N5230A-01B**S E R V I C E****N O T E**Supersedes:
N5230A-01A**N5230A PNA Series RF Network Analyzers**

Many of the Front Panel Interface (FPI) boards which were installed per Service Note N5230A-01A need to be modified or replaced because the RPG shaft can disconnect, and the front panel keyboard and RPG can respond intermittently upon boot up.

Figure 1

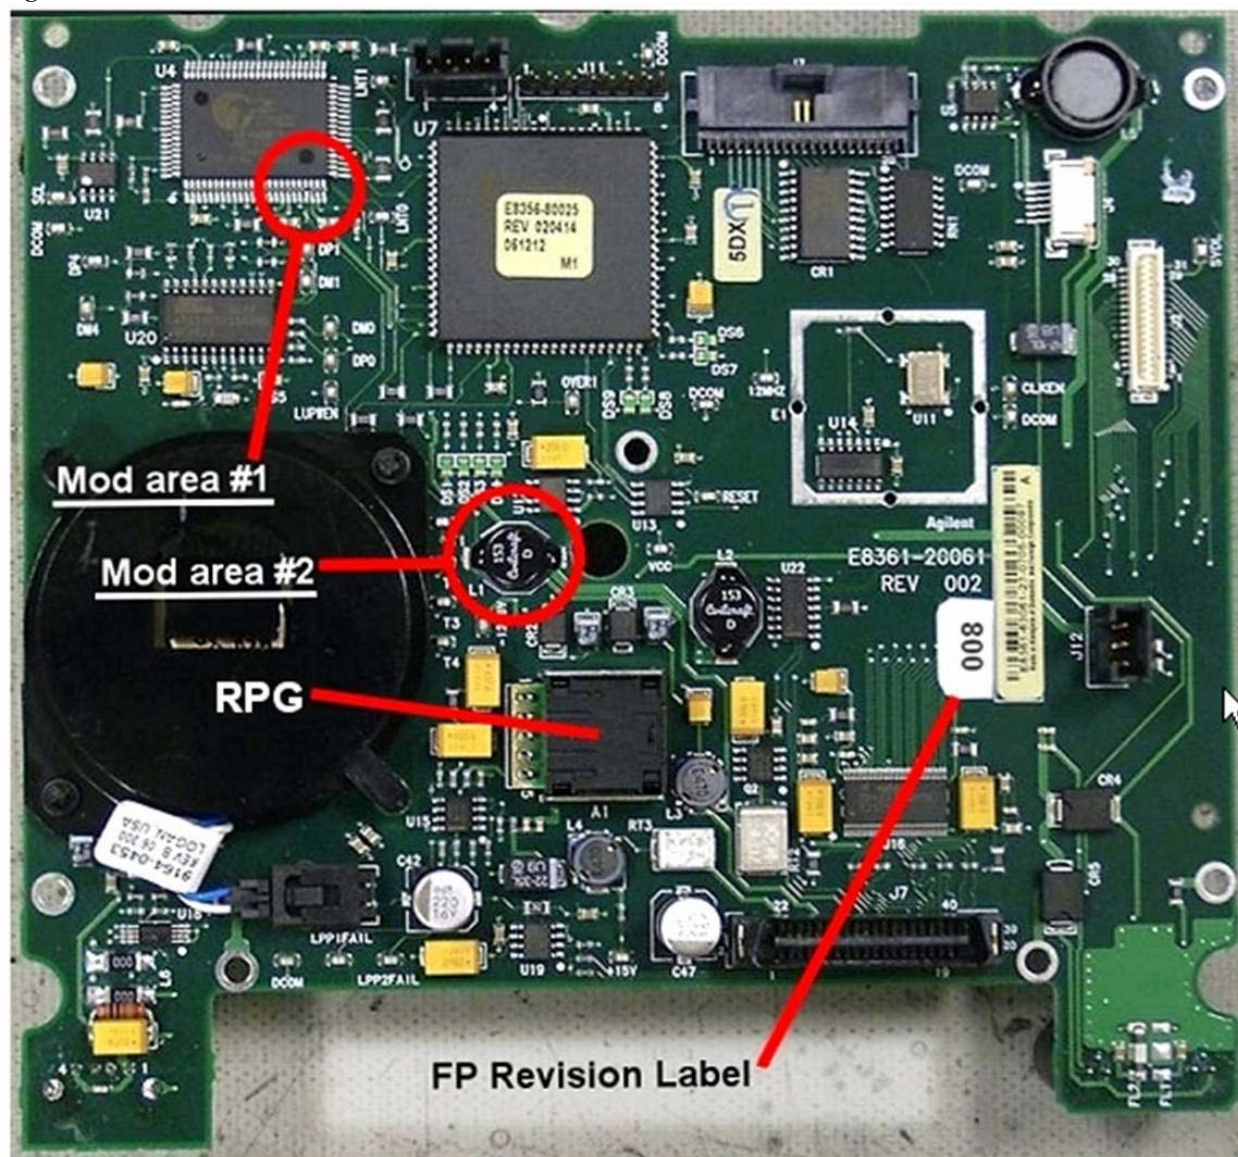
Refer to Figure 1 for the two modification areas to be addressed. Note that while this picture happens to show the FPI board completely removed from the front frame assembly, this is not necessary to perform the required modifications.

- Modification #1 consists of shorting two pins of U4 together with a small amount of solder.
- Modification #2 consist of removing L1.

Unsolder and completely remove the black surface mount inductor L1 from the front panel assembly board. This is no longer needed and can be discarded.

Figure 2

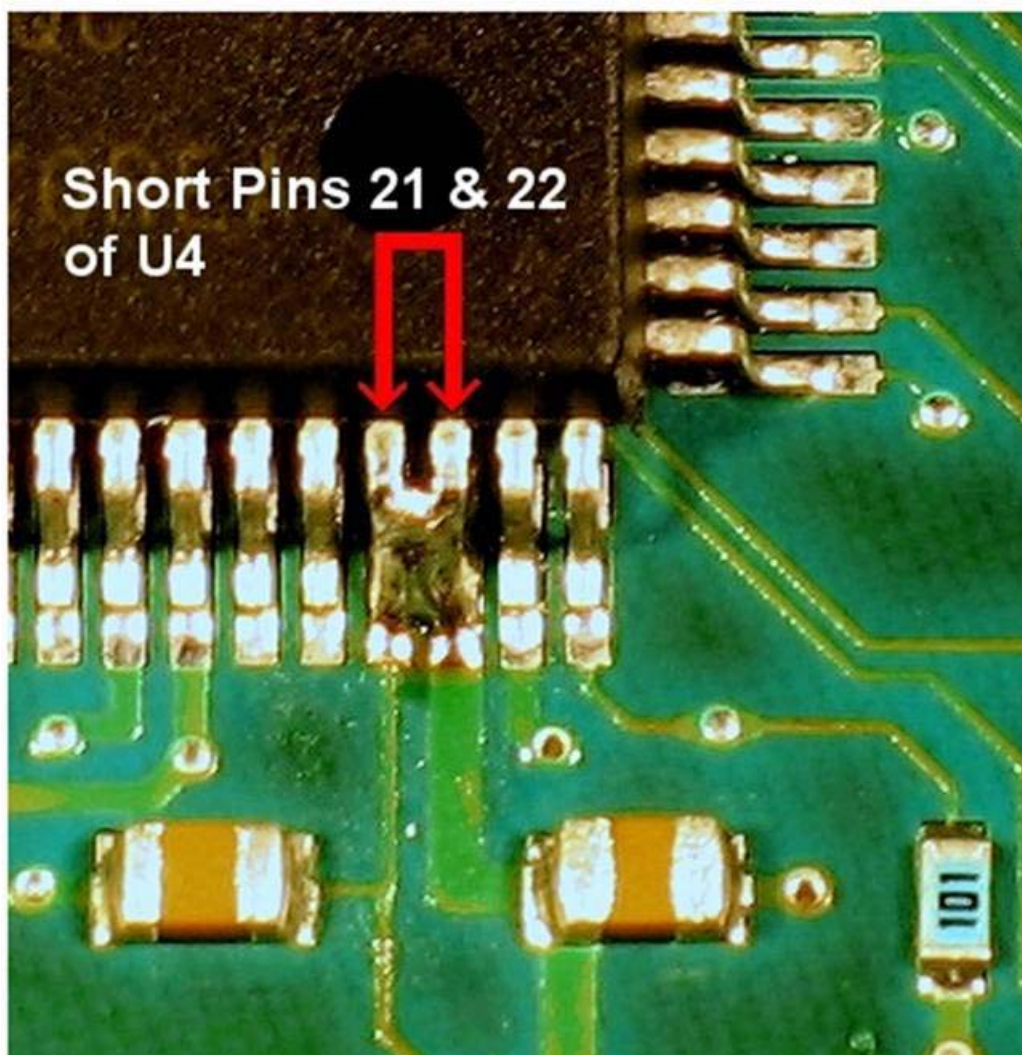
Carefully solder pins 21 and 22 together on U4. Refer to Figure 2 for the exact location. Use care so that no other pins are shorted. Use of a very fine tip soldering iron is recommended and a large work-task magnifying glass is very helpful.
